REDLANDS SUBDIVISION, PHASE 1

Revised for the April 19th meeting:

Revised for the May 17th meeting:

<h2 style="margin: 0;">DETAIL SITE PLAN</h2>
--

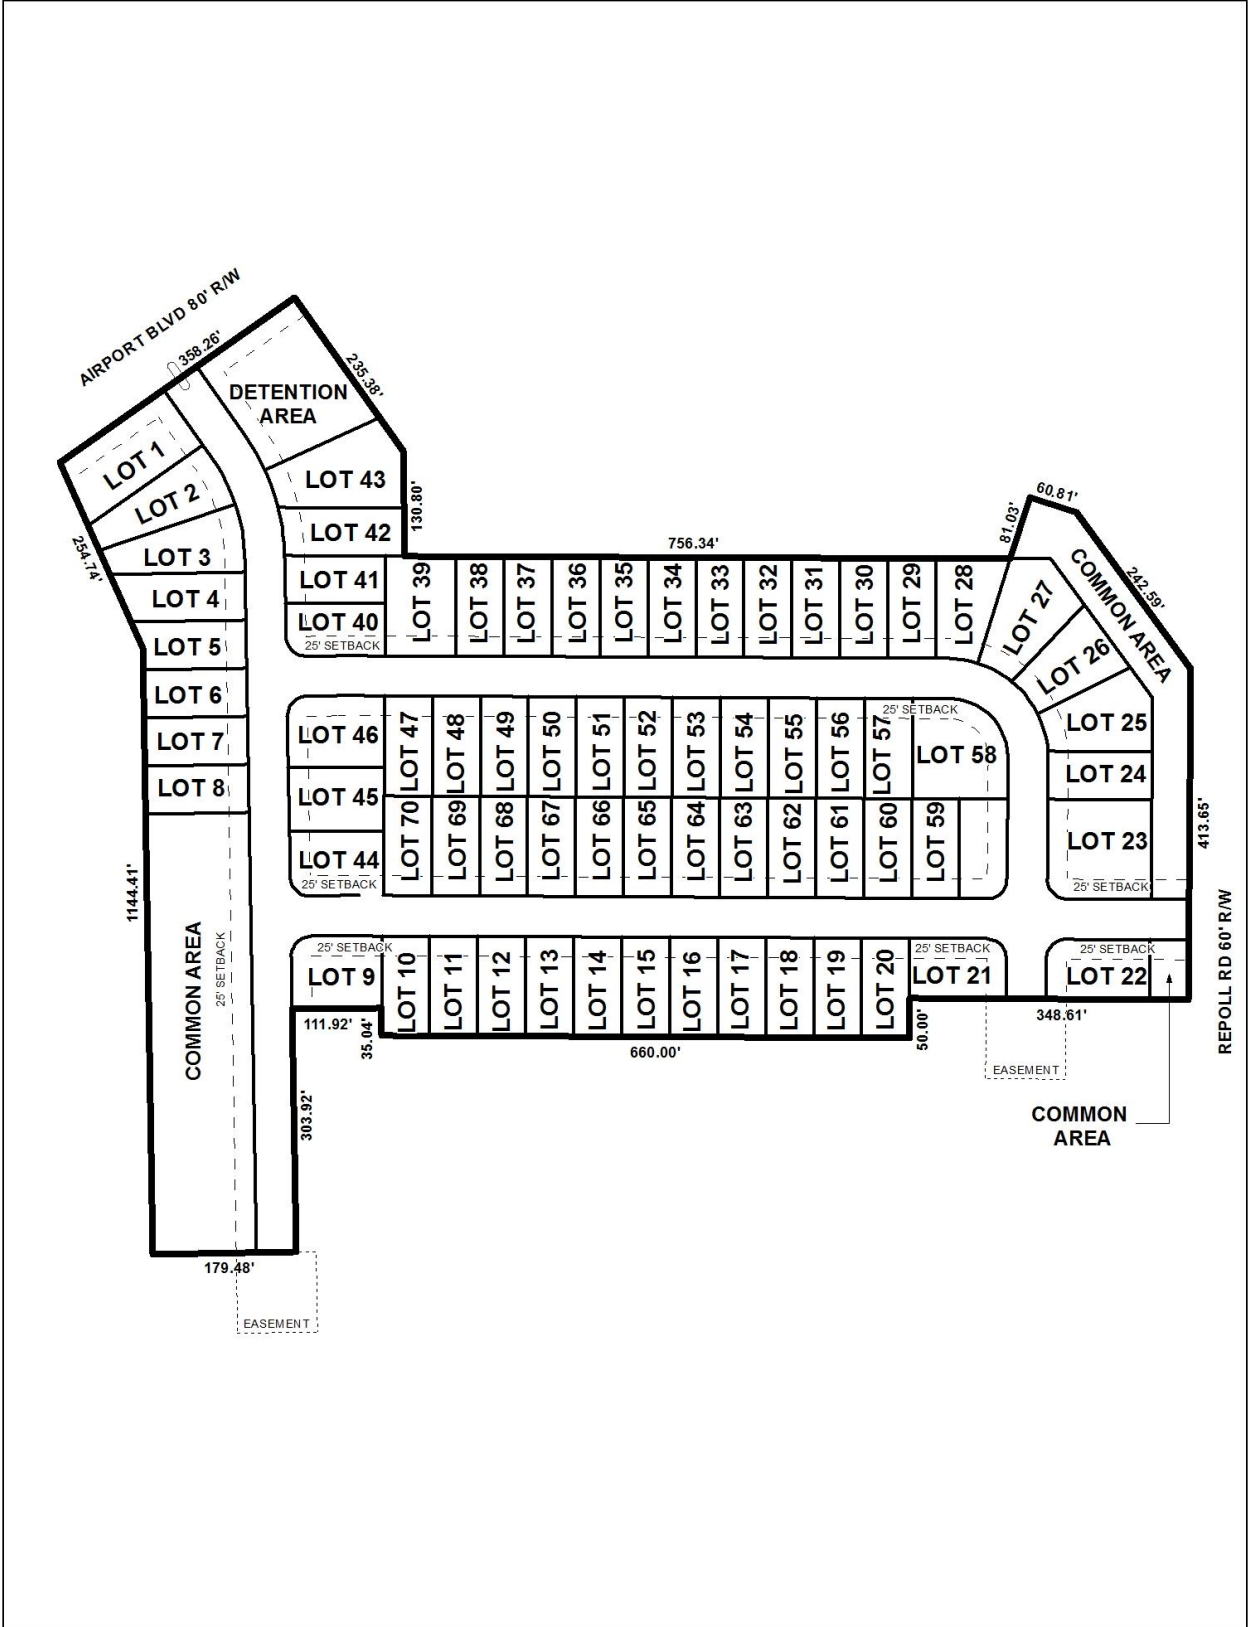
The preliminary plat for Redlands Subdivision, Phase 1 is a 20.79 ± acre development consisting of 70 lots, 4 common areas, and one detention area. The lot sizes appear to meet the size requirements; however they are not labeled in square feet or acres, nor is there a chart reflecting that information. It appears that the smallest lot is roughly 7,405 square feet while the majority of the other lots are 7,500 square feet. If approved, a revised plat depicting the lot sizes in square feet and acres or a chart illustrating that information will be required.

The 25' minimum building setback lines are depicted on the plat and if approved, should be retained on the Final Plat.

The right-of-way widths along Airport Boulevard and Repoll Road are not depicted. The plat should be revised to depict the current right-of-way-widths for both streets.

As a means of access management each lot and the four common areas should be limited to one curb-cut each to the streets internal to the development, and denied direct access to Airport Boulevard and Repoll Road. The size, design and location of all curb-cuts should be approved by County Engineering and comply with AASHTO standards. All roads proposed within the subdivision must be built to County Engineering standards and accepted by the County, prior to the signing of the plat for each phase for recording.

As mentioned, four common areas are depicted on the preliminary plat. A note should be placed on the final plat stating that maintenance of the common areas are the responsibility of the subdivision's property owners, and not Mobile County.

It should be pointed out there are two temporary turn-around easements with Phase 1 of the Redlands Subdivisions. The turn-arounds should be maintained until such time as the abutting phases are developed.
